# Addendum

**Project:** Harris County Psychiatric Center Renovation  
Units 1C, 2E, 3B, 3C, 3D, & 3E

**Addendum No.:** 002

**Date:** November 14, 2016

**A2.08B**

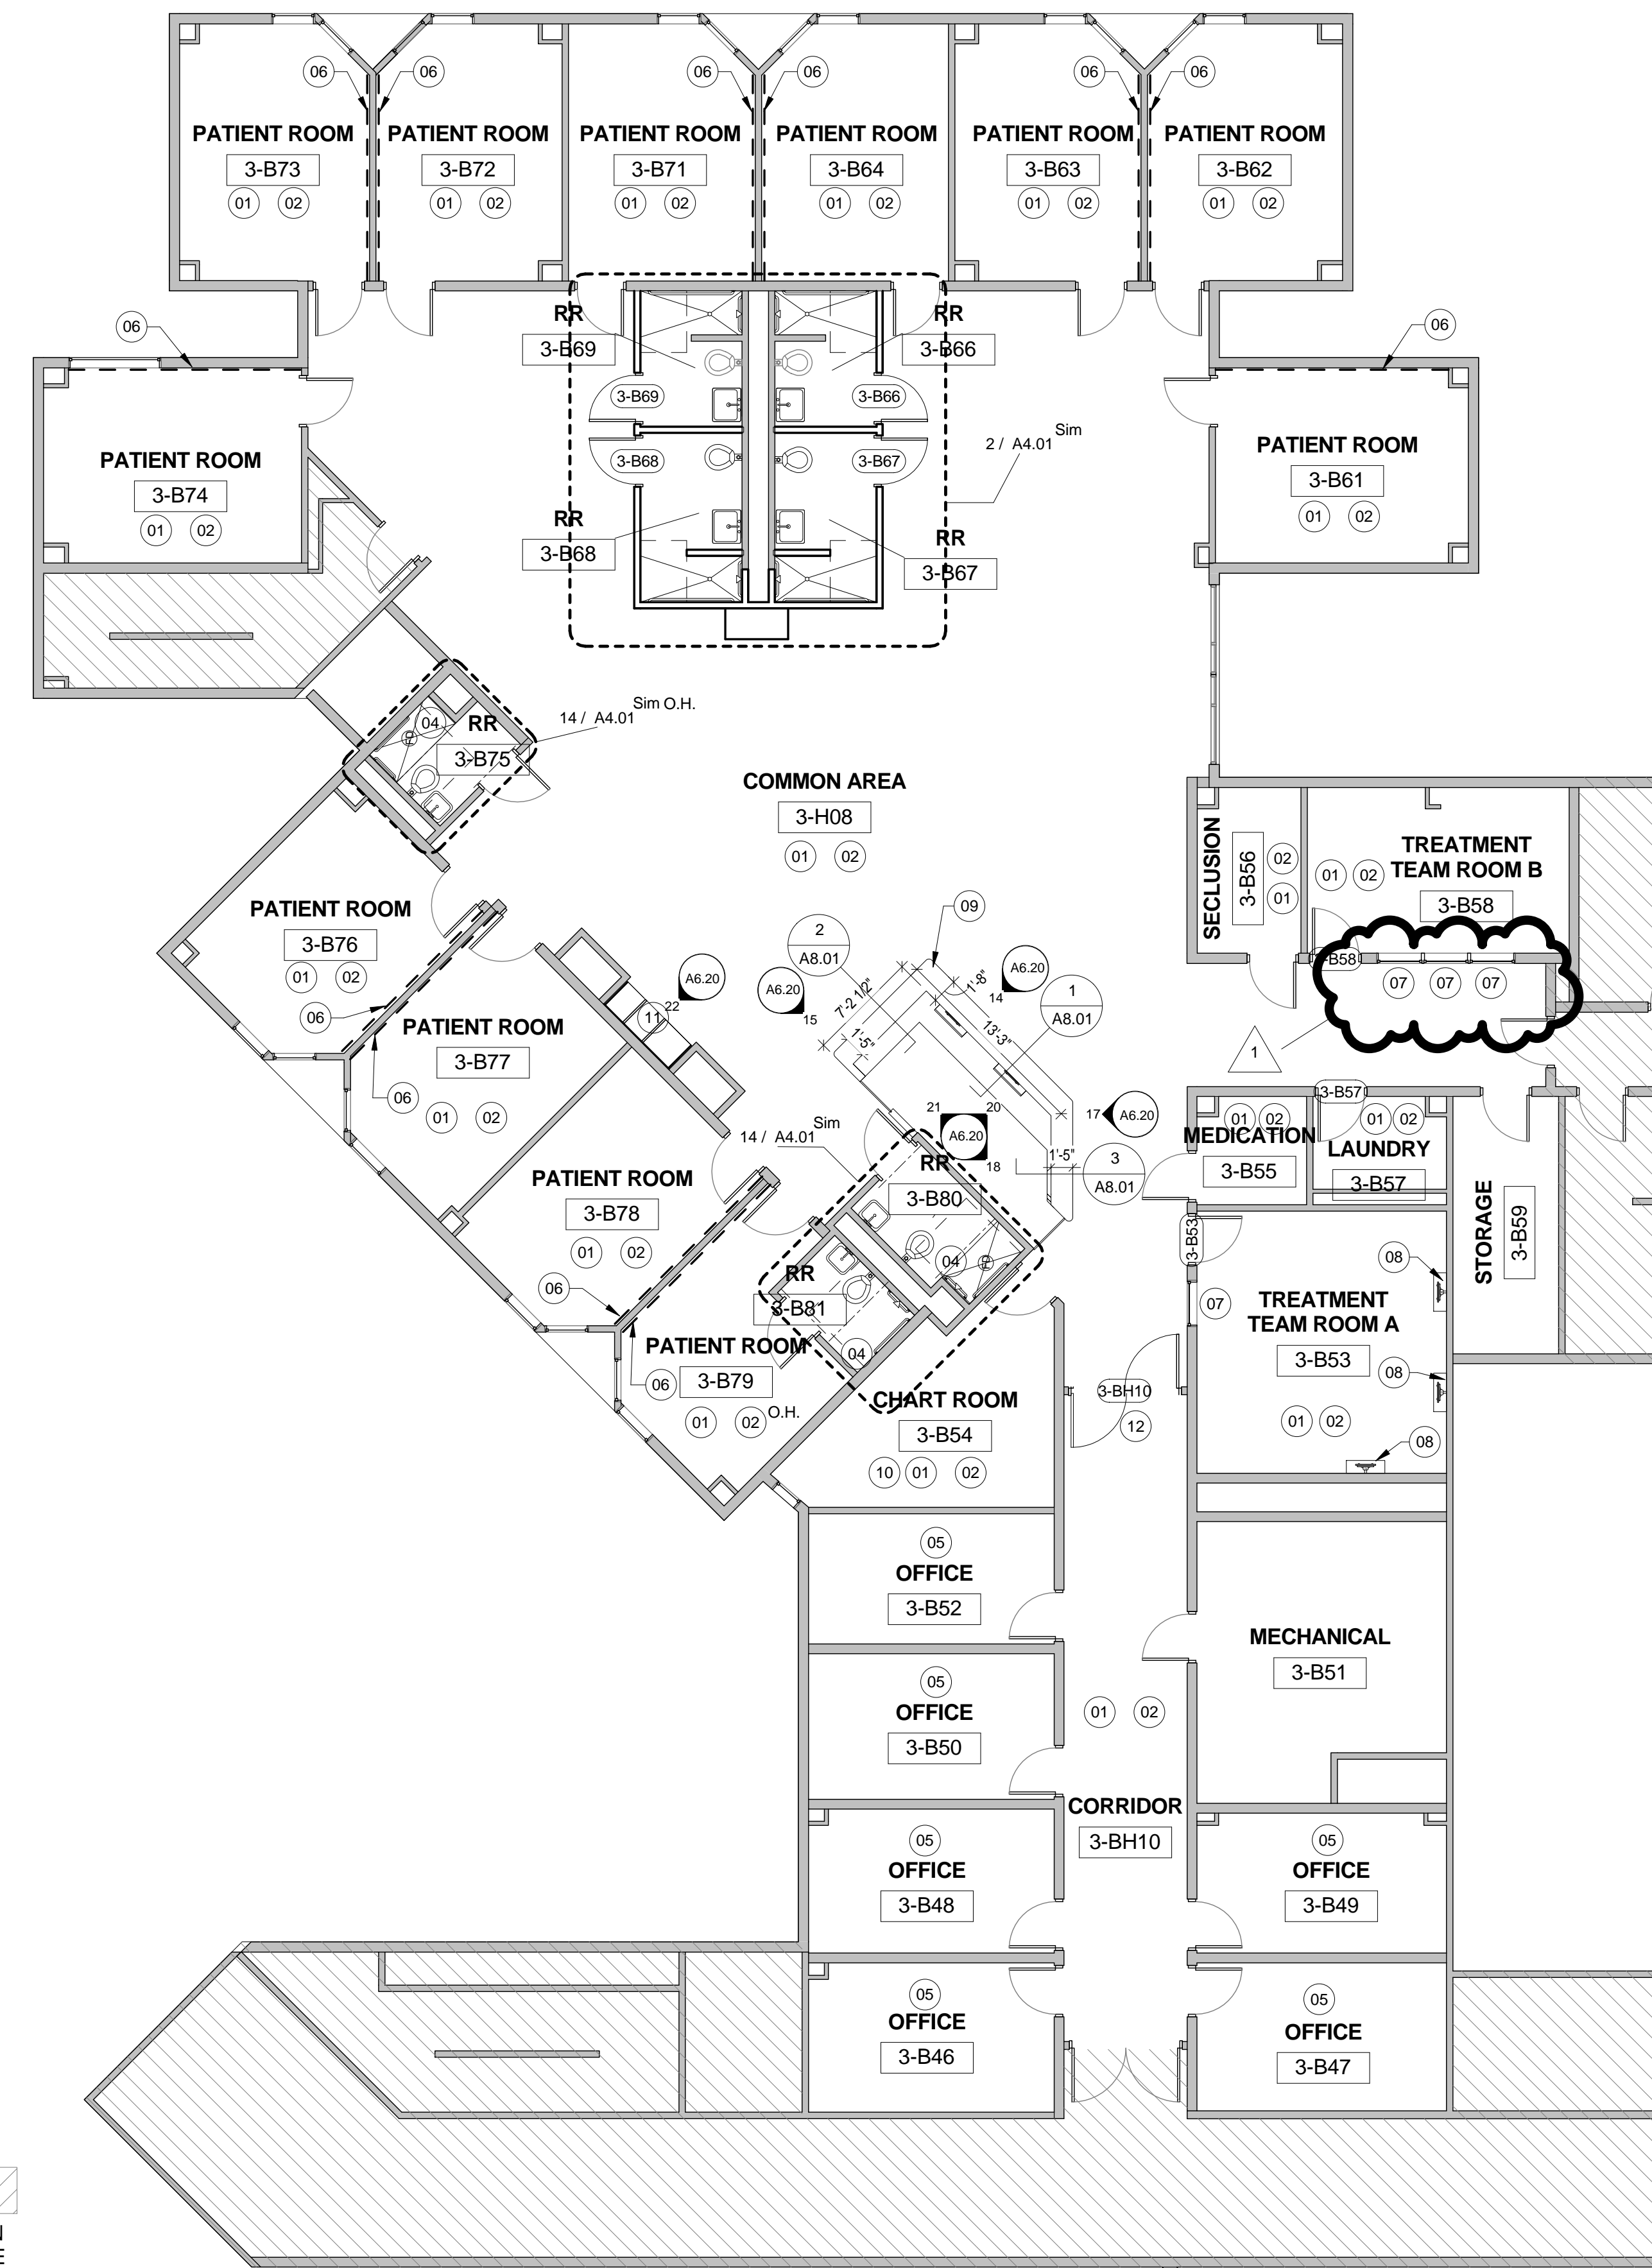
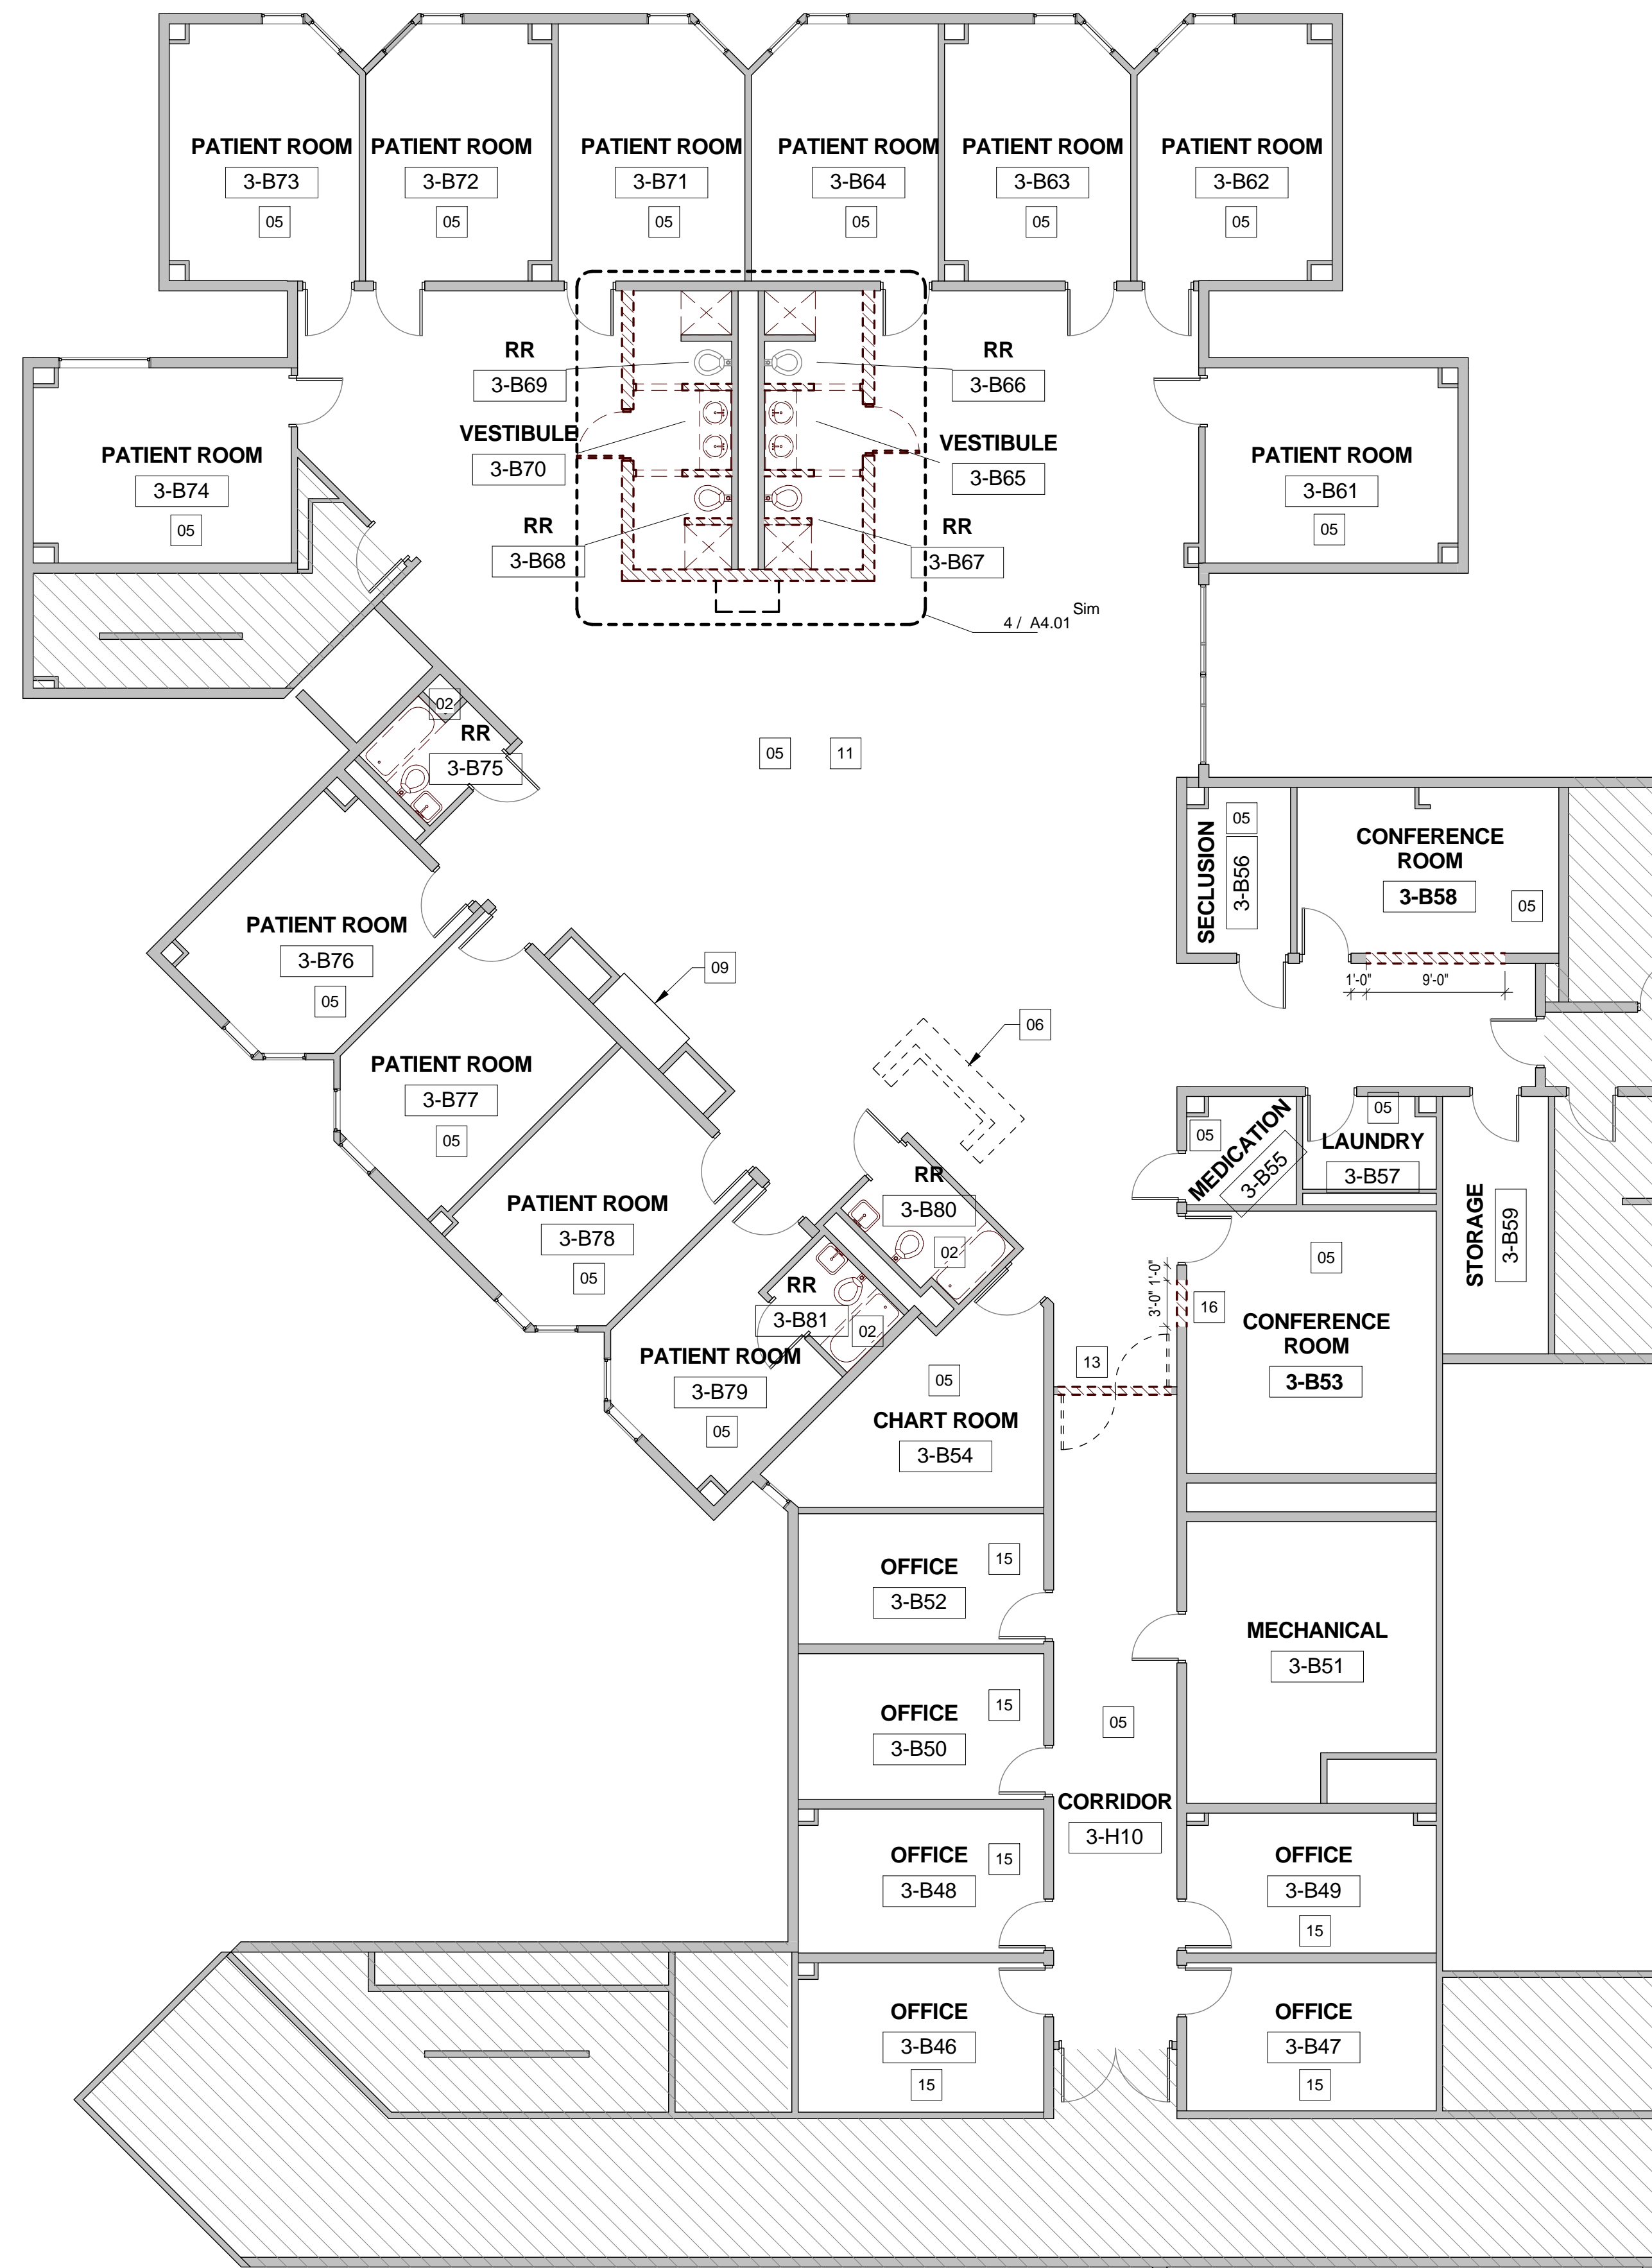
6. Sheet A2.08B, Third Floor Unit 3B, revised to reflect changes to keyed notes on demolition and/or renovation plans. (see attached)
7. Sheet A2.19C, First Floor Finish Plan – Unit 1C, revised to reflect changes to LVT-1 flooring specification and addition of flooring pattern(s) and grain direction(s) in Common Area. (see attached)

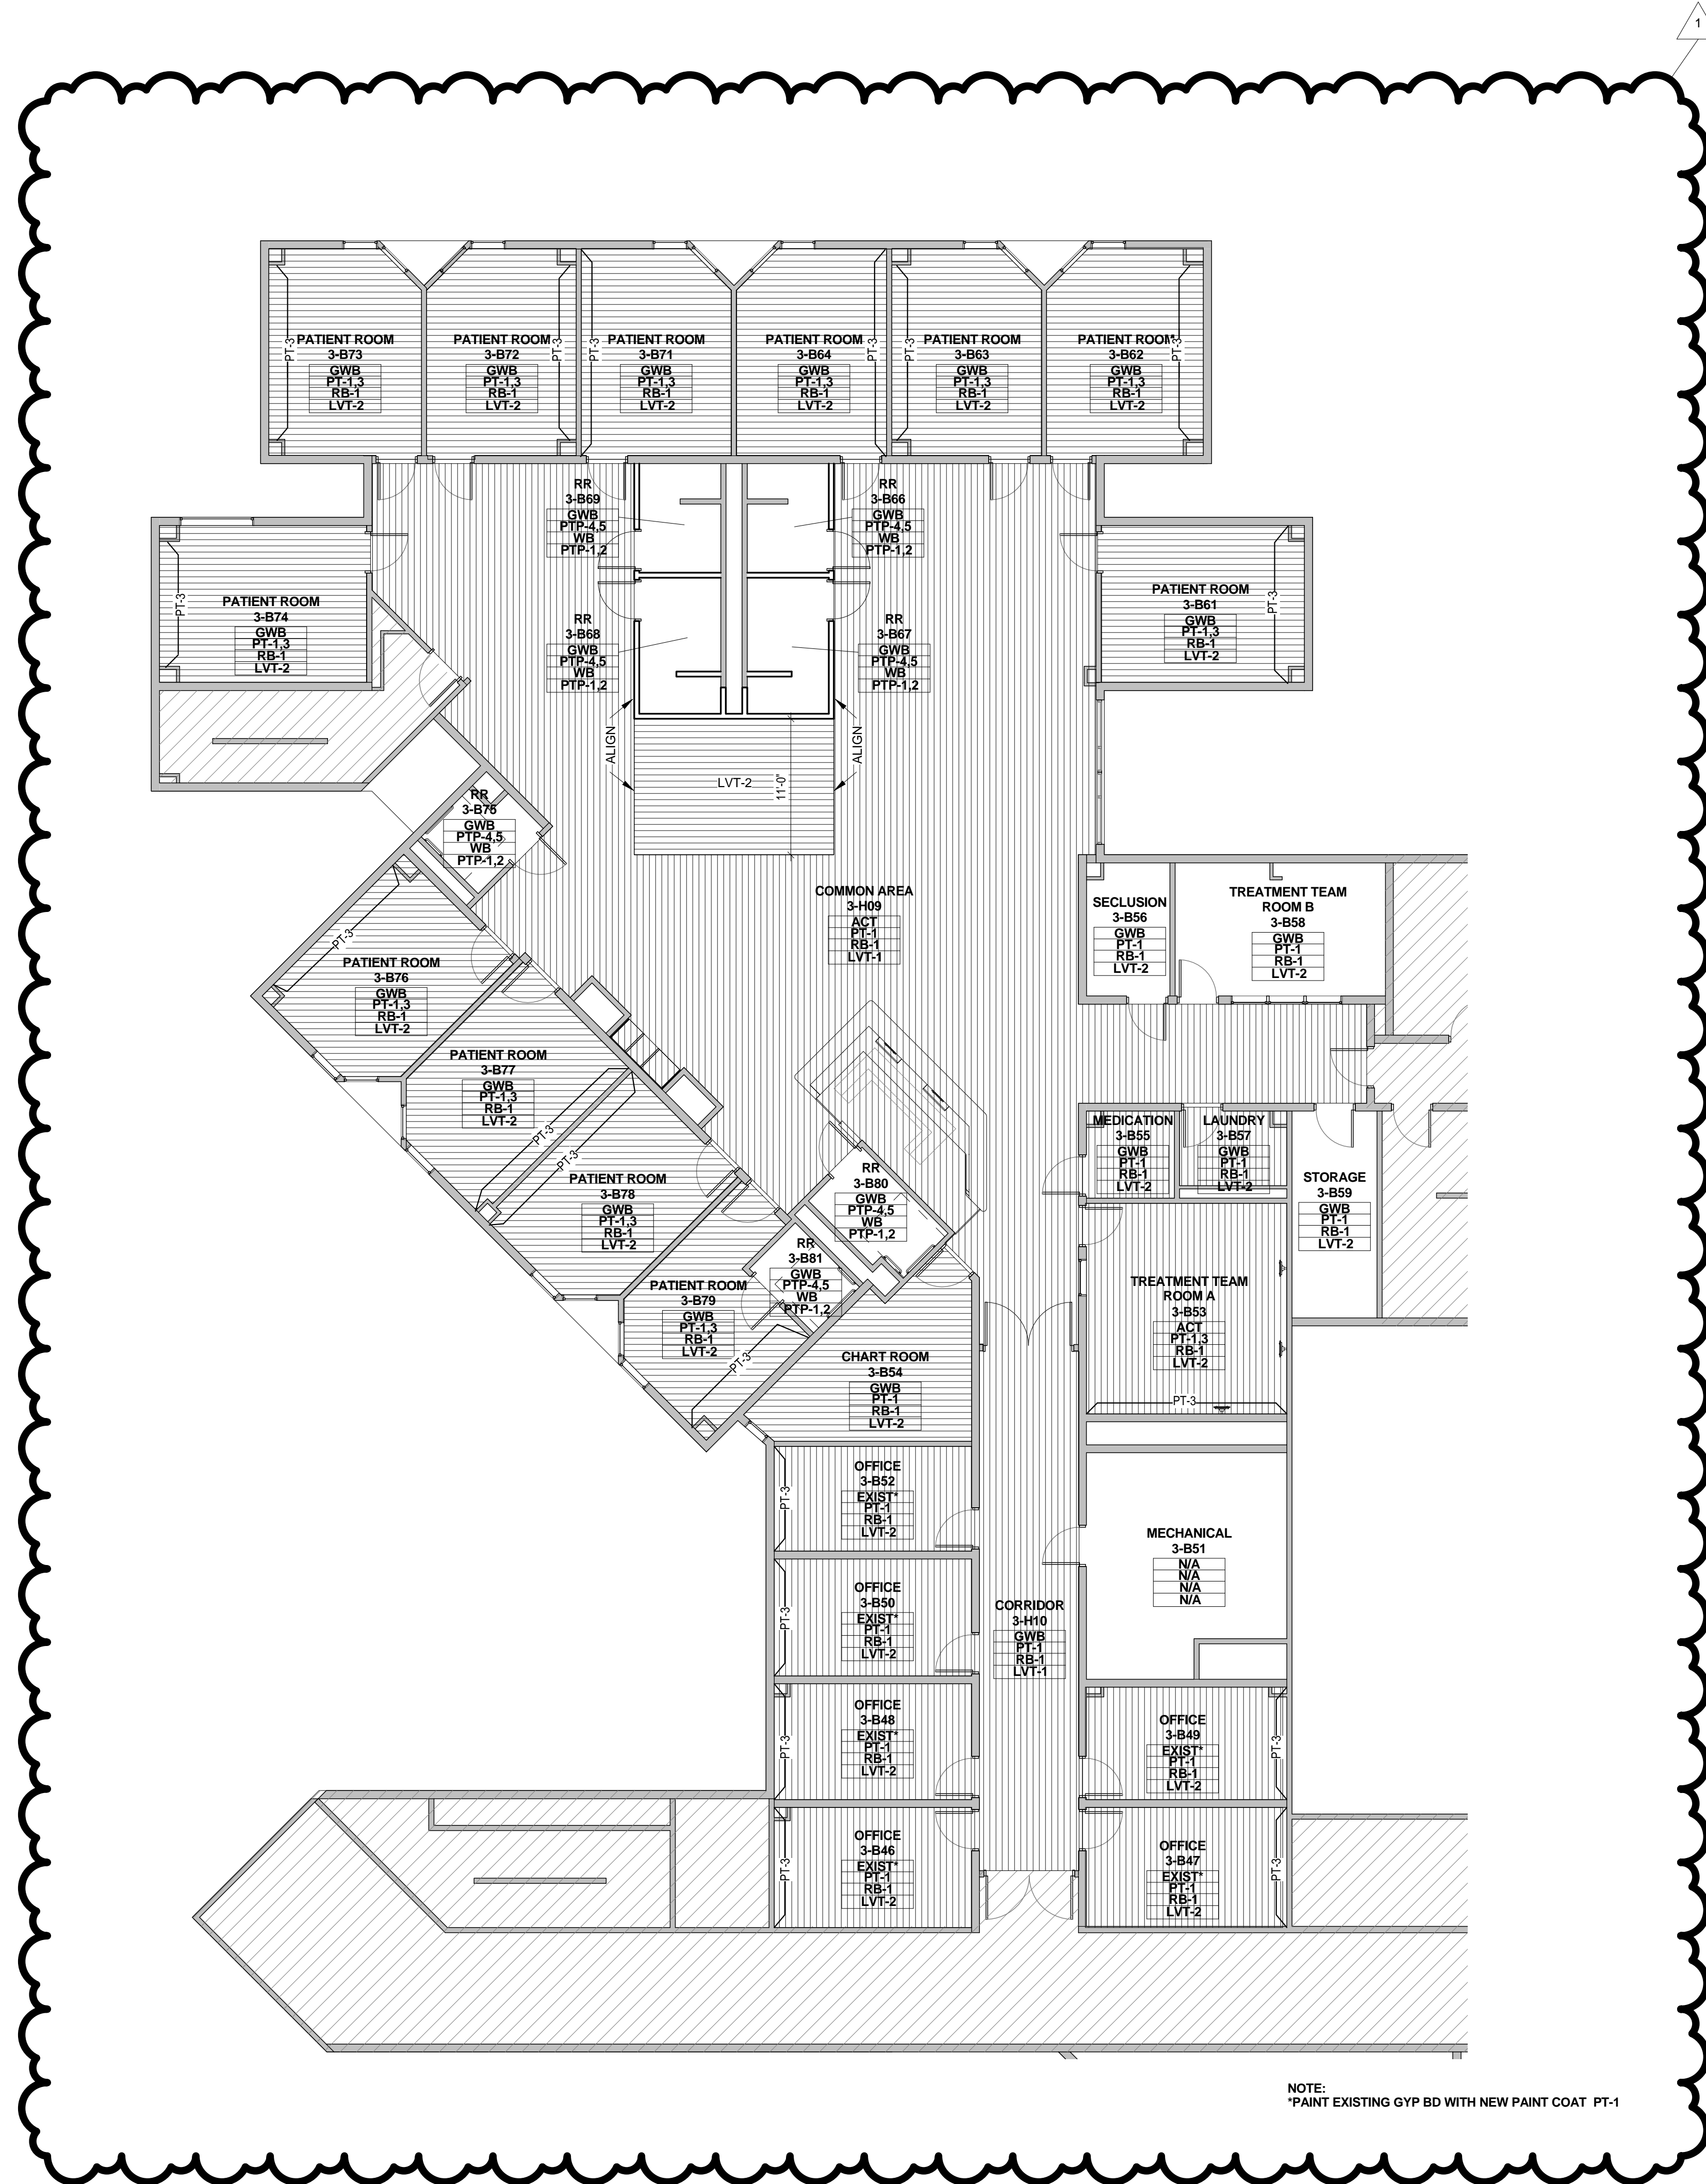
8. Sheet A2.20E, Second Floor Finish Plan – Unit 2E, revised to reflect changes to LVT-1 flooring specification and addition of flooring pattern(s) and grain direction(s) in Common Area. (see attached)
